Response to Submissions

Berrima Colliery Continued Operations MP 10_0172
Berrima Cement Works DA No. 401-11-2002-i MOD 6
Prepared for Boral Cement Limited | November 2011

Report 09022RP3 | Prepared for Boral Cement Limited | 21 November 2011

Figure No: 1

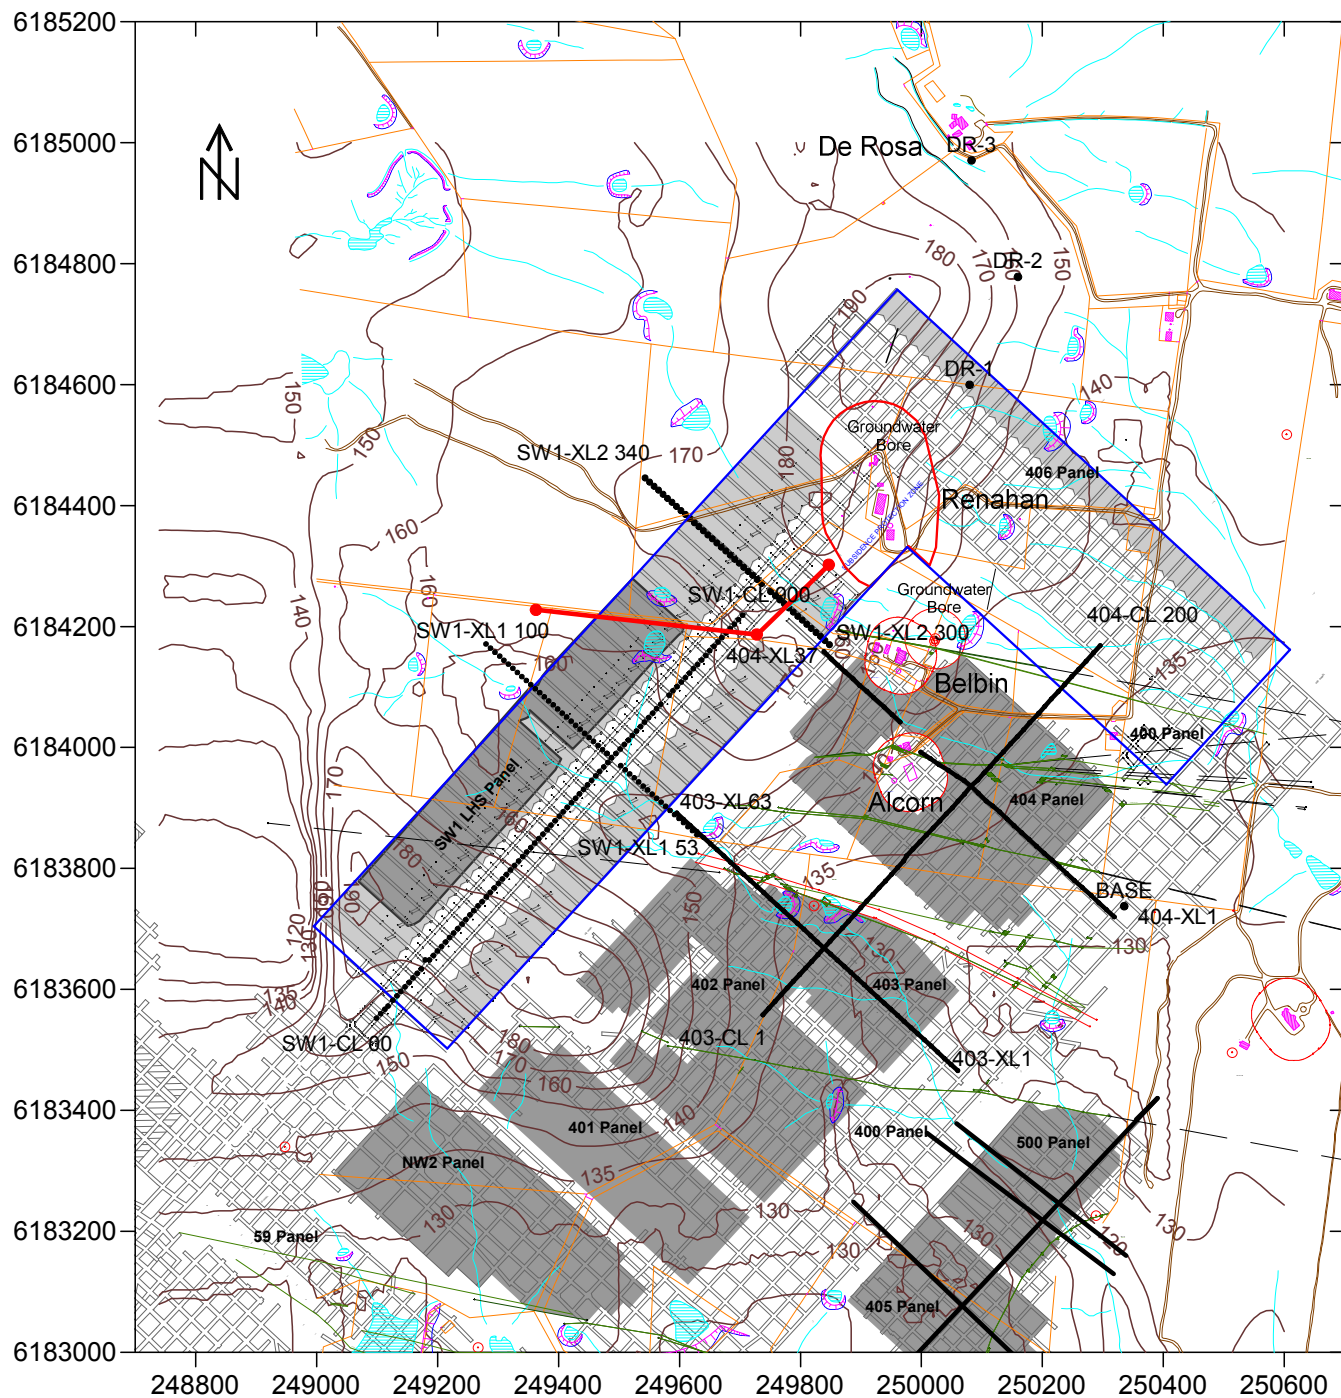
Paragraph 2 - It is commented on that it is unclear whether some or all of the first workings pillars have been removed from the NW2, 401 - 405 and 500 Panels (excluding the subsidence protection zones) as shown in Figure 1 of the SA Report. It is also suggested that the EA report has “presented a chequer board mine layout that implies coal pillars remaining”.

Response: **Figure 1** attached shows the zones of first workings headings and standing pillars in between or outside the limits of the pillar extraction (i.e. second workings) areas at Berrima Colliery. The LHS portion of the SW1 panel that has been ‘totally extracted’ to-date is also shown.

It is understood that the dark grey shaded zones in **Figure 1** were ‘totally extracted’ unless remnant coal pillars had to be left behind to provide temporary roof support in difficult ground conditions. It is not considered critical that every remnant coal pillar location is known about in these second workings areas. Maximum subsidence effect data has only been used from previous panels where a reasonable level of mining geometry confidence is known to the author.

Response: The previous and proposed first and second workings areas shown in **Figure 1** are understood to be correct. Historically, the first workings pillars in a given panel were lifted or extracted down the LHS first on the advance. The mine would then lift the pillars on the RHS on retreat out of the panel. First workings pillars were recommended to be left within a Subsidence Protection or Control Zone based on a design angle of draw line taken down from the existing residences to the workings.

During the recent hand over between mine operators, it should be understood that the original mining methodology proposed for the SW1 for the SMP was to extract the LHS of the panel as currently shown, and then removing the RHS pillars on retreat (including the central access main pillars). However, a mine planning decision was subsequently made to leave the central access headings pillars as shown in **Figure 1**.
